## NOBLE VILLAGE JSP22-26

Consideration of Noble Village at the request of Detroit Architectural Group for approval of the Preliminary Site Plan. The subject site contains 3.85 acres and is located at 42705 Grand River Avenue, east of Novi Road, and south of Grand River Avenue, which is in Section 23. The applicant is proposing a range of improvements to the current site of One World Market and the former Library Pub. These improvements include major changes to the façade of the building, landscape changes, and a total of 2,170 square feet in building additions to accommodate a few new uses of the site including an expanded Asian Grocery Store (One World Market), an Asian food hall anchored by Noble Fish Sushi and White Wolf Japanese Patisserie, an Izakaya bar, and community meeting spaces on the second and third floor of the building.

# PLAN REVIEW CENTER REPORT

**Review Date:** September 14, 2022  
**Review Type:** Preliminary Site Plan Review  
**Project Name:** **JSP22-26 NOBLE VILLAGE**  
**Location:** 42705 Grand River Ave, Suite 201, 22-23-176-016  
**Plan Date:** August 1, 2022  
**Prepared by:** Christian Carroll, Planner  
**E-mail:** [ccarroll@cityofnovi.org](mailto:c

TITLE: **SITE PLAN**

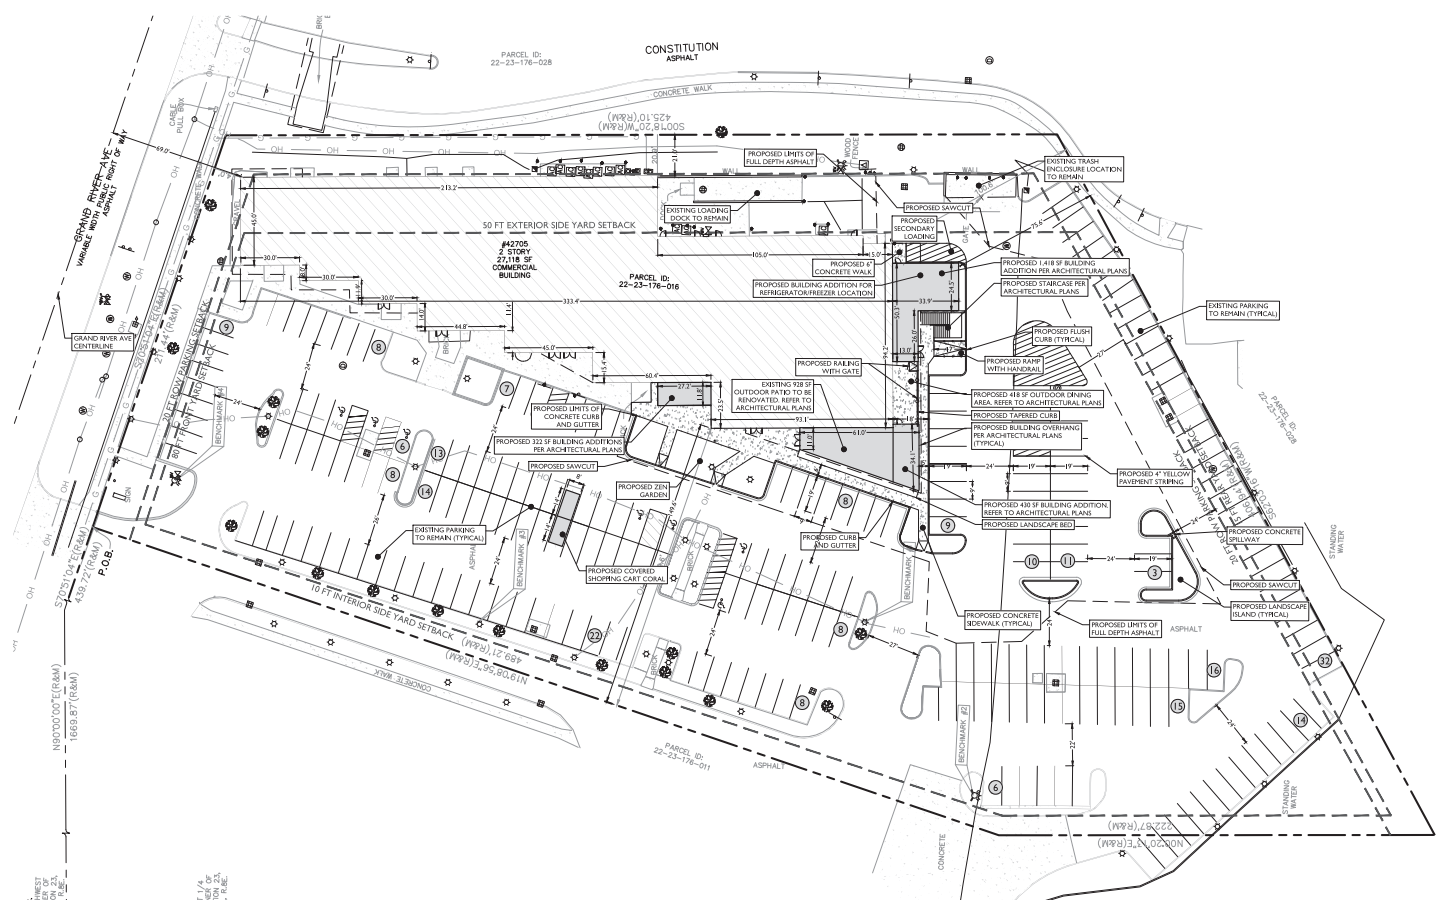
**Response:** This information has been made available on Sheet C-3 as previously submitted. It can be revised to be clearer on future submission.

SCALE: 1" = 50' PROJECT ID: DET-21041  
 TITLE: VEHICLE TURNING PLAN

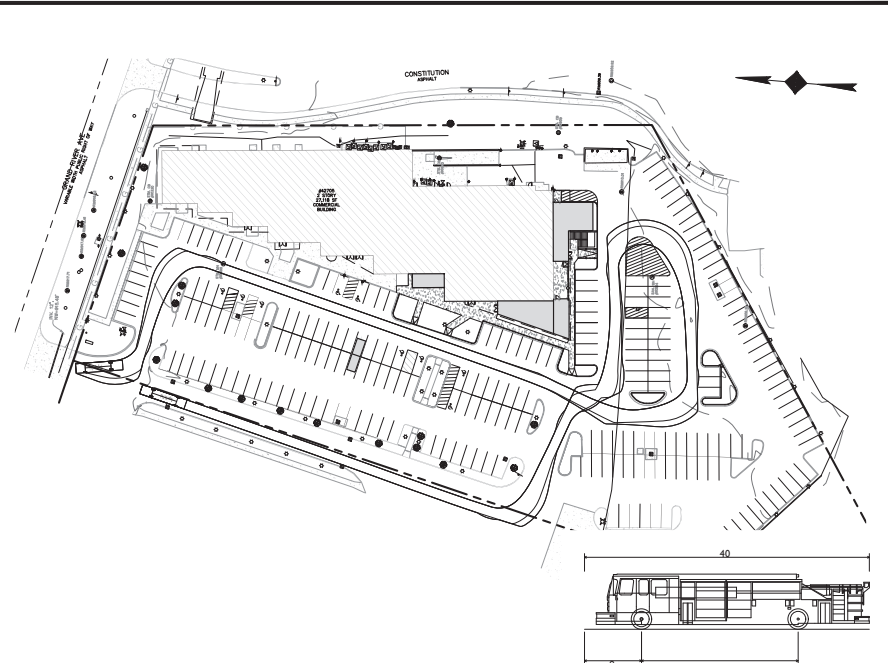
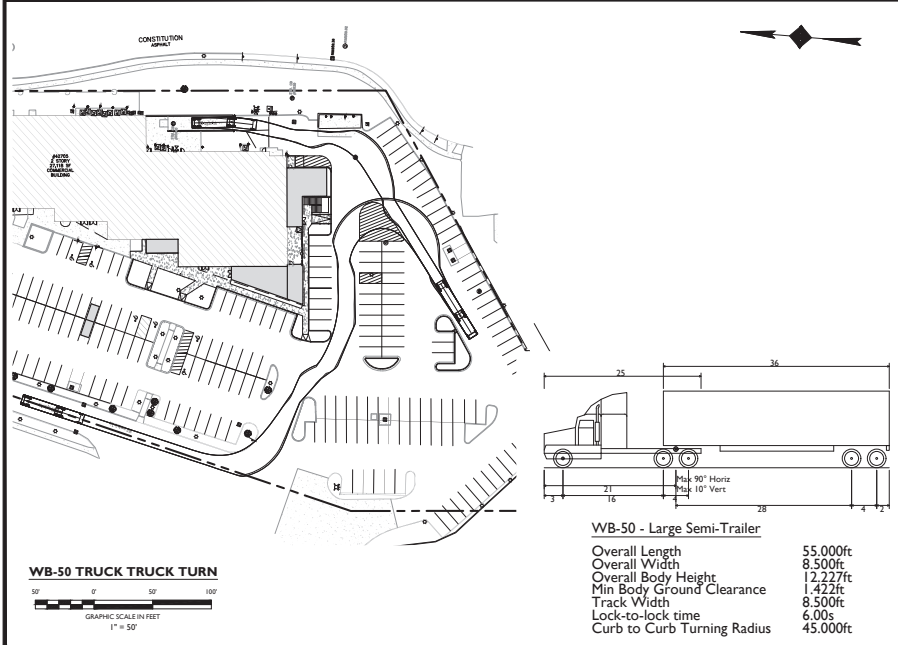
**Response:** The waivers are requested as many of the existing and proposed landscaped islands do not meet the width and radii requirements. This is due to the proposed reconfiguring of the southern parking lot. While the requirements are not met everywhere the intent is to maximize the available landscaping area while maintaining the existing traffic aisles. The ‘striped’ island is unfortunately required to allow for the larger trucks to successfully navigate the site. Please refer to Sheet C-11 of the Site Development Plans for circulation analysis.

DRAWN BY: MV  
 CHECKED BY: BK  
 IN CHARGE: BK  
 SHEET NAME:  
 EXTERIOR ELEVATIONS

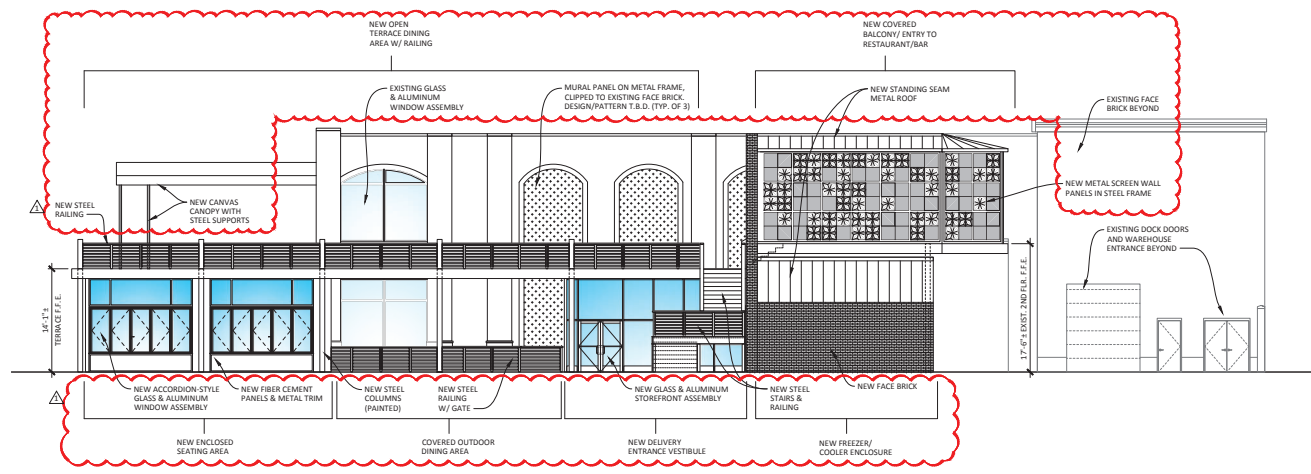
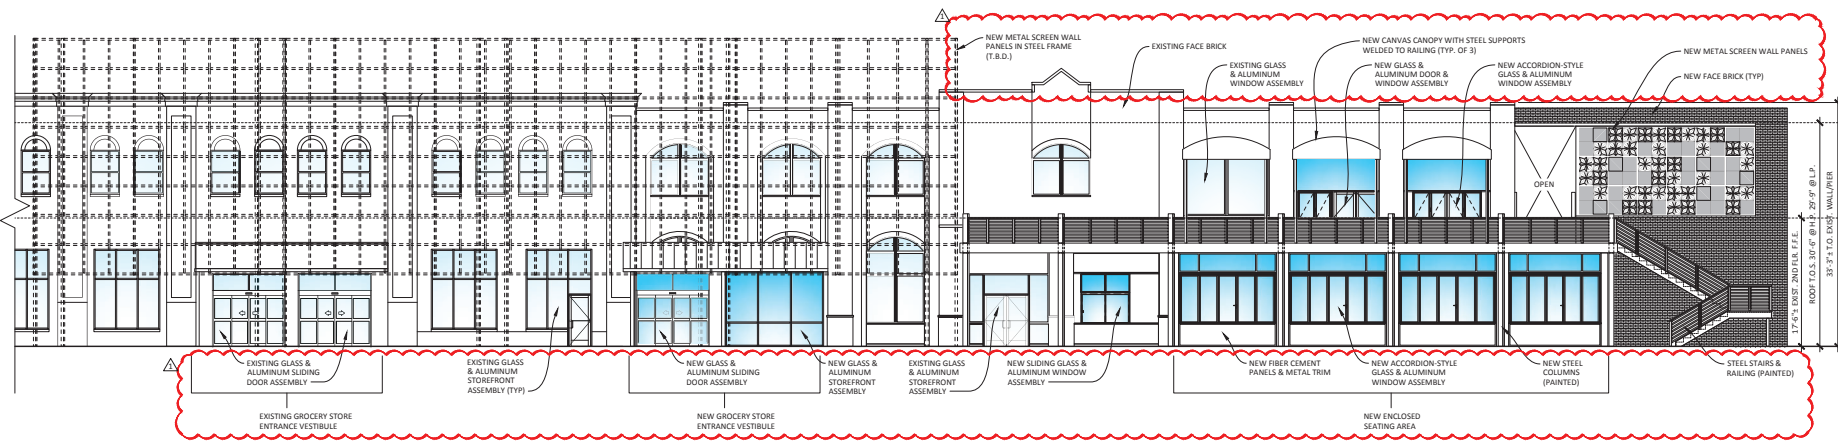
- g. Section 9 Façade Waiver for a minor overage of Fiber Cement Panel on the West and South Elevations *because the overall design is consistent with the intent and purpose of the Façade Ordinance, which is hereby granted;*
- h. The findings of compliance with Ordinance standards in the staff and consultant review letters and the conditions and the items listed in those being addressed on the Final Site Plan; and
- i. *(additional conditions here if any)*

3. Façade Materials (Sec. 3.27.1.G): All sides of the building must have the same materials. Façade materials may deviate from brick or stone with Planning Commission approval. **The City's Façade Consultant supports the changes to the appearance of the site and recommends approval of the Preliminary Site Plan. A Section 9 Façade Waiver for minor overage of Fiber Cement Panels on the West and South Elevations is supported by the City's Façade Consultant and will require Planning Commission consideration.**
